APPLICATION NO.	FILING DATE	FIRST NAMED INVENTOR	ATTORNEY DOCKET NO.	CONFIRMATION NO.
10/577,541	04/28/2006	Daisuke Matsumoto	10921.403USWO	9838
52835 7590 07/07/2010 HAMRE, SCHUMANN, MUELLER & LARSON, P.C. P.O. BOX 2902			EXAMINER	
			SCHUBERT, CHRISTOPHER	
MINNEAPOLIS, MN 55402-0902			ART UNIT	PAPER NUMBER
			3734	
			MAIL DATE	DELIVERY MODE
			07/07/2010	PAPER

Application No.	Applicant(s)			
	10/577,541	MATSUMOTO ET AL.			
Office Action Summary	Examiner	Art Unit			
	CHRISTOPHER SCHUBERT	3734			
The MAILING DATE of this communication app Period for Reply	ears on the cover sheet with the c	orrespondence address			
A SHORTENED STATUTORY PERIOD FOR REPLY WHICHEVER IS LONGER, FROM THE MAILING DA  - Extensions of time may be available under the provisions of 37 CFR 1.13 after SIX (6) MONTHS from the mailing date of this communication.  - If NO period for reply is specified above, the maximum statutory period w  - Failure to reply within the set or extended period for reply will, by statute, Any reply received by the Office later than three months after the mailing earned patent term adjustment. See 37 CFR 1.704(b).	ATE OF THIS COMMUNICATION 66(a). In no event, however, may a reply be

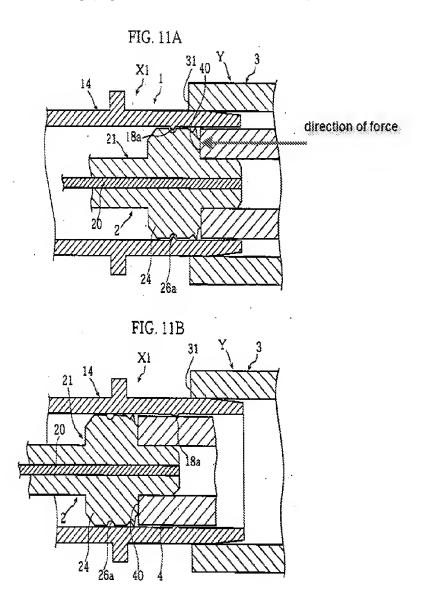
Regarding claims 1-3, Koike et al. disclose a lancet comprising a lancet body (2A, 2B including stopper 71A,71B) provided with a lancing element (20), and a casing (1A, 1B) including a space (10) extending throughout the casing for retaining the lancet body therein (Fig. 20A and 21), wherein the lancet body is fixed to the casing (in the "wait position") when an external force exceeding a predetermined level in a particular direction is not applied to the casing (paragraphs 81 and 106-110), whereas the lancet body becomes movable relative to the casing when an external force exceeding the predetermined level in the particular direction is applied to the casing (paragraphs 81 and 106-110), wherein the casing has a cross-sectional shape which changes when the external force exceeding the predetermined level in the particular direction is applied to the casing; and wherein the lancet body becomes movable relative to the casing when the cross-sectional shape of the casing is changed. The cross-sectional shape changes in the sense that movable pieces (70A) are pushed out of the way allowing the stopper (71A) and the lancet body (2A) to move relative to the casing (paragraphs 81 and 106-110; Fig.

19, 20A, 20B, and 21). Koike et al. disclose the particular direction crosses a direction in which the space extends and the particular direction is directed from an outside of the casing toward an inside of the casing (Fig 11a and 11b annotated below).

- 1. Applicant's arguments filed 10/19/2009 have been fully considered but they are not persuasive.
- 2. Examiners rejection of claim 1 above with annotated figures 11a-b shows that the force from 40 is directed from the outside of the casing toward an inside of the casing.

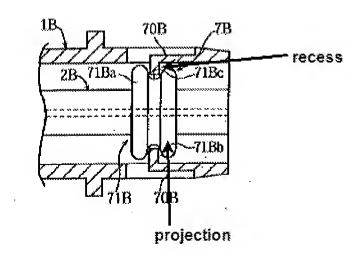
Regarding claim 6, Koike et al. disclose the contact portion comprises a recess (see figure below), and wherein the lancet body is provided with a projection (see figure below) for coming into engagement with the recess (Fig. 21).
